Bayside Planning Panel

Item No	5.1
Application Type	Development Application
Application Number	DA-2017/183
Lodgement Date	22/11/2016
Property	24 Oswell Street, Rockdale
Owner	Mr H Jouni and Mrs W Hijazi
Applicant	Space 0.618:1
Proposal	Construction of a two (2) storey detached dual occupancy development, including roof top terraces, basement parking, front and side fences, demolition of existing structures and Torrens title subdivision from one lot into two lots
No. of Submissions	Six submissions from four submitters – One is supportive
Cost of Development	\$725,000.00
Report by	Michael Maloof, Senior Development Assessment Planner

Planning Assessment Report

Application Number:	DA-2017/183
Date of Receipt:	22 November 2016
Property:	24 Oswell Street, Rockdale NSW 2216
Owner:	Mrs Wafaa Hijazi and Mr Haithem Jouni
Applicant:	Mr Haithem Jouni
Proposal:	Construction of a two (2) storey detached dual occupancy development, including roof top terraces, basement parking, front and side fences, demolition of existing structures and Torrens title subdivision from one lot into two lots
Recommendation:	Refusal
No. of Submissions:	Six (6) submissions from four (4) submitters have been recei

Figure 10 – Street view image looking north-west up Holland Ave, illustrating the indicative location of proposed driveways, garage doors, and removal of vegetation and street trees, resulting in the increased visibility of the proposed development.

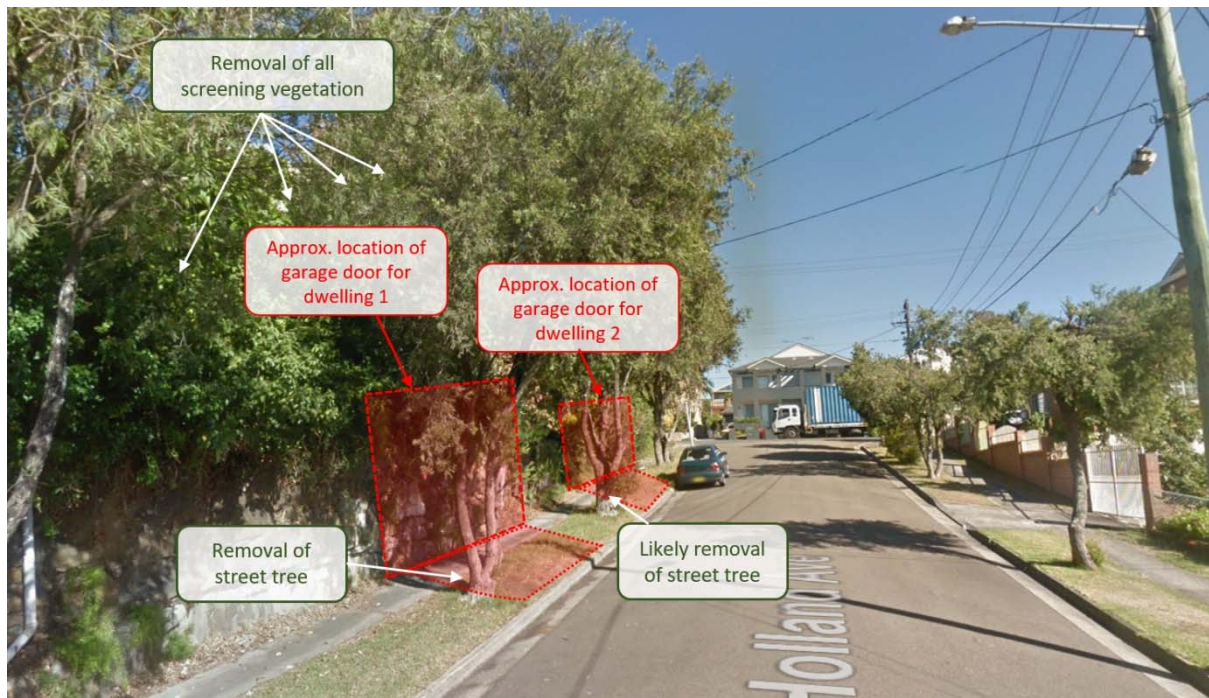
As highlighted by the annotations within **Figure 10**, the proposed development will become comparatively more visible within the Holland Avenue streetscape should the proposed works to remove the existing vegetation on the subject site and the Callistemon street trees be approved. The visibility of the subject site will further be exacerbated because of the scale of the proposed development, being comprised of two (2) x two-storey dwellings on the subject site and involving significant excavation into the rock face of the Holland Avenue frontage.
